SUBJECT: NuScale Power, LLC Response to NRC Request for Additional Information No. 03 (eRAI No. 8744) on the NuScale Design Certification Application

Enclosure 1: NuScale Response to NRC Request for Additional Information eRAI No. 8744

NRC Question No.: 15.02.08-1

Figure 15.2-44: Hot Channel Node MCHFR - ~~Peak RCS Pressure~~ Limiting MCHFR Case (15.2.8 Feedwater Line Break)

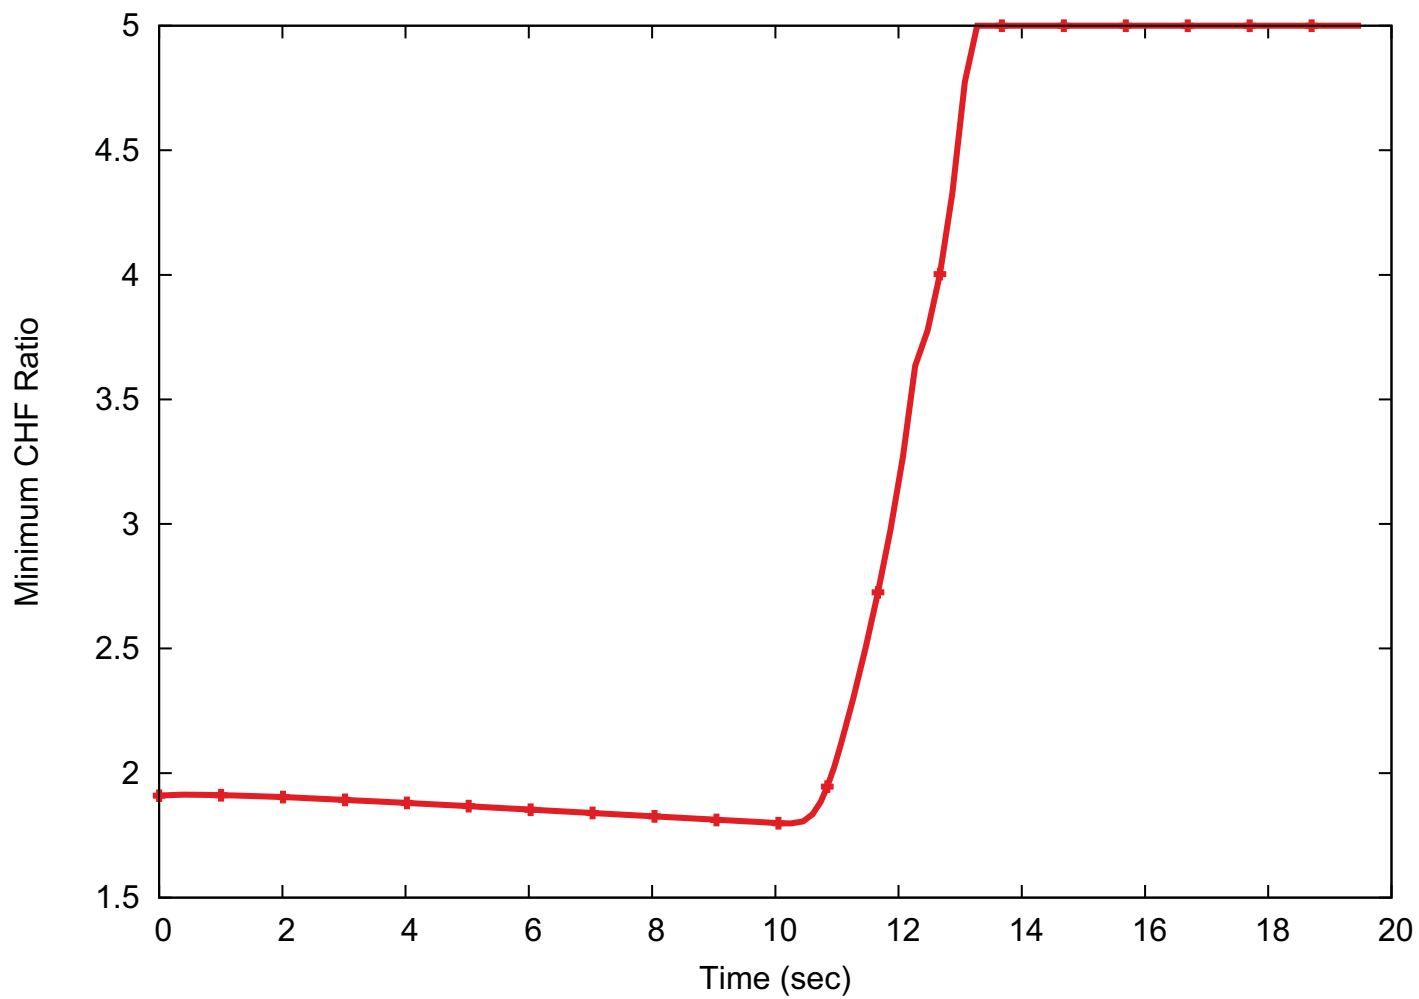
In Final Safety Analysis Report (FSAR) Tier 2, Section 15.2.8.4, "Input Parameters and Initial Conditions," the applicant states that a 30% uncertainty is added to the steam generator heat transfer. However, in FSAR Tier 2, Table 15.2-28, "Biases and Uncertainties – Feedwater Line Break," the applicant states that a -30% uncertainty is used for the steam generator heat transfer. The staff notes that these statements in the FSAR are inconsistent. Based on the docketed information, the staff is unable to determine what uncertainty value is used for the steam generator heat transfer and the adequacy of the reported 30% uncertainty addition to the steam generator heat transfer. The staff requests the applicant to clearly state in the FSAR which uncertainty value is used and provide justification in the FSAR as to why the applicant adds to (or subtracts from) the steam generator heat transfer.

For the DEG FWLB evaluated for the limiting SG pressure, the highest pressure was obtained by using a positive 30% heat transfer bias, no fouling and no SG tube plugging. However the DEG FWLB was not the limiting break for SG pressure. Smaller breaks of 8% to 10% of feedwater flow with a negative 30% primary to secondary heat transfer bias, a large fouling factor and 10% tube plugging, resulted in slightly higher SG pressure. The 10% FWLB with failure of the feedwater isolation valve (FWIV) backflow prevention device was selected as the representative limiting SG case for the sequence of events FSAR Table 15.2-25 and SG pressure FSAR Figures 15.2-42 and 15.2-43. Similar FWLBs, 4% to 8% break size, with the same heat transfer biases, resulted in the minimum critical heat flux ratio (MCHFR). The 8% FWLB was selected as the representative limiting MCHFR case for the sequence of events in FSAR Table 15.2-26 and MCHFR Figure 15.2-44. Note that the title of FSAR Figure 15.2-44 was mislabeled as the MCHFR for the “Maximum RCS Pressure Case” and has been corrected to be the “Limiting MCHFR Case” as shown in the attached FSAR markup.

FSAR Sections 15.2.8.2, 15.2.8.4, 15.2.8.5, and FSAR Figure 15.2-44 have been revised as described in the response above and as shown in the markups provided in this response.
